Technical Service Bulletin

Subject: REAR COMBINATION LIGHT(S) ARE FOGGY	Bulletin No.: 09-014/19
	Last Issued: 03/15/2019

This bulletin supersedes the previously issued bulletin(s) listed below. The changes are noted in Red text.

2017-2018 CX-5 vehicles with VINs lower than JM3KF*****356208 (produced before Feb. 6, 2018)

CONDENSATION RUNNING DOWN LENS - REPLACE LIGHT UNIT

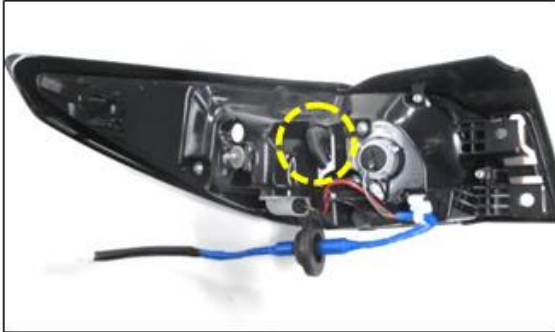
1. Verify the customers concern of condensation inside the rear combination lights.
 - a. If condensation is found inside, replace both rear combination light units with new parts according to the instructions on MGSS online (REAR COMBINATION LIGHT REMOVAL/INSTALLATION).
 - b. If condensation is not found inside, go to Step 2.

FOGGY UNIT - DO NOT REPLACE LIGHT UNIT

Symptom	Step / Action
Condensation running down lens	Step 1a: Replace rear combination light unit
Foggy Unit / No drops on lens	Step 5: Dry inside unit for (20) minutes; install ventilation caps
Non-Foggy Unit	Step 6: Dry inside unit for (1) minute; install ventilation caps

LIGHT UNIT, RIGHT

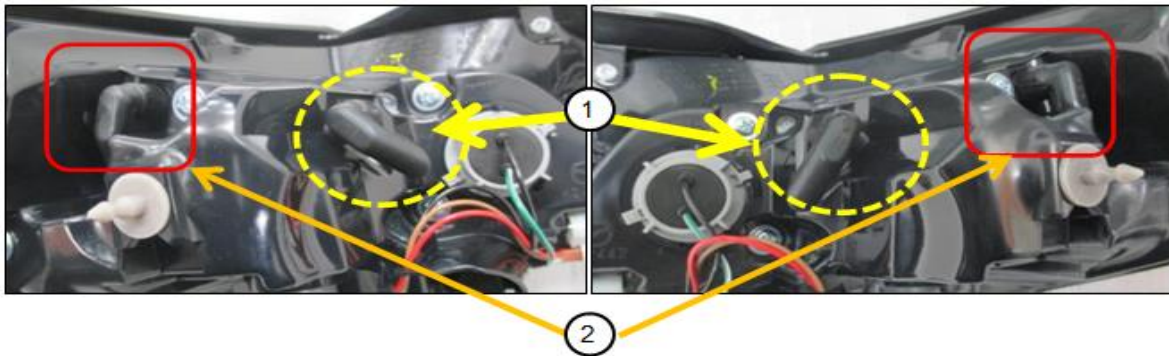
2. Remove the rear combination light unit according to the instructions on MGSS online (REAR COMBINATION LIGHT REMOVAL/INSTALLATION).
3. Remove the ventilation tube from the back of the light unit.

NOTE: Bulb type rear combination lights have two ventilation tubes. Remove only the inner ventilation tube (1). Do not remove the outer ventilation tube (2).
